Hesitation On Acceleration From a Slow Roll or Rolling Stop

Service Category Engine/Hybrid System

YEAR(S)	MODEL(S)	ADDITIONAL INFORMATION
2019	RAV4

REVISION NOTICE

Figure 1. Location of Authorized Modifications Label on 2019 RAV4

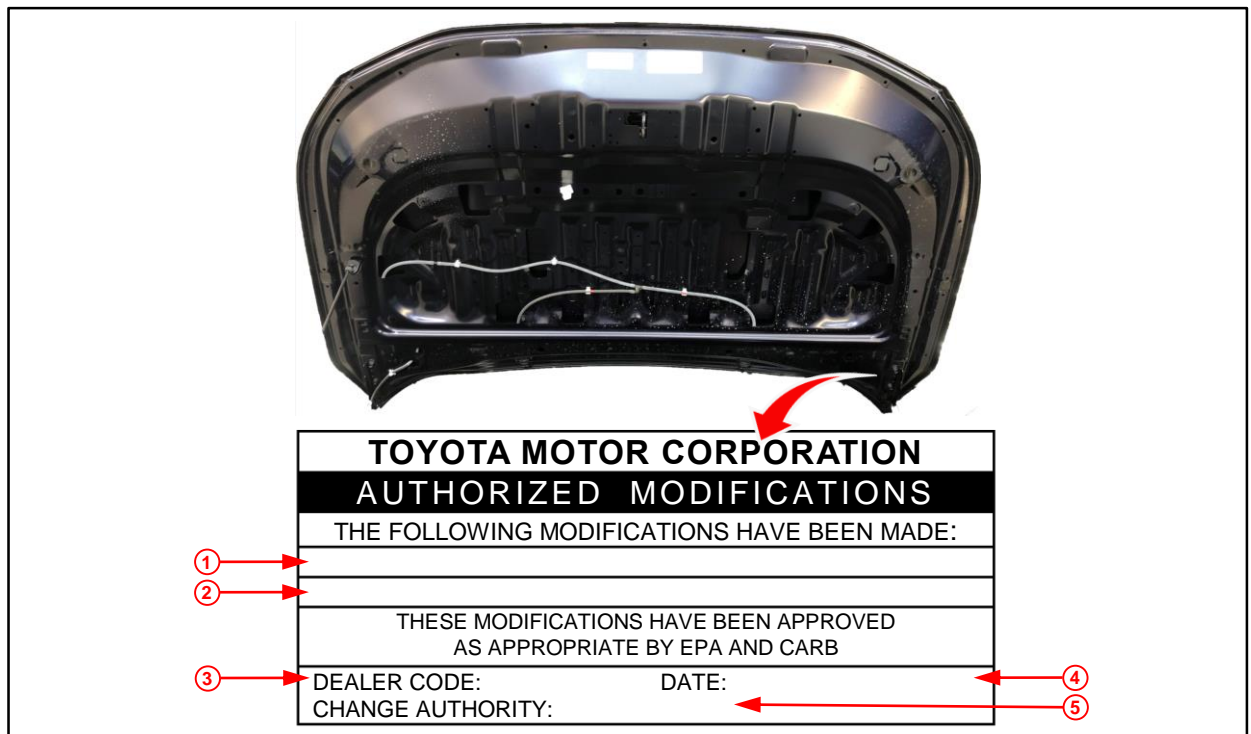
- Use Techstream to confirm if the ECM (PCM) calibration has been updated and check for the Authorized Modifications Label affixed to the vehicle in the location shown below.

Is the calibration ID listed in Techstream and on the label the latest ECM (PCM) calibration?

4. Prepare and install the Authorized Modifications Label.
 - A. Using a permanent marker, enter the following information on the label:
 - ECM (PCM) part number [*Refer to the **Parts Information** section for the **NEW PART NUMBER***]
 - Calibration ID(s) [*Refer to the **Calibration Information** section for the **NEW CALIBRATION ID***]
 - Dealer Code
 - Repair Date
 - Change Authority [***This bulletin number***]
 - B. Install the Authorized Modifications Label onto the vehicle at the location shown in Figure 1. The Authorized Modifications Label is available through the MDC, P/N 00451-00001-LBL.
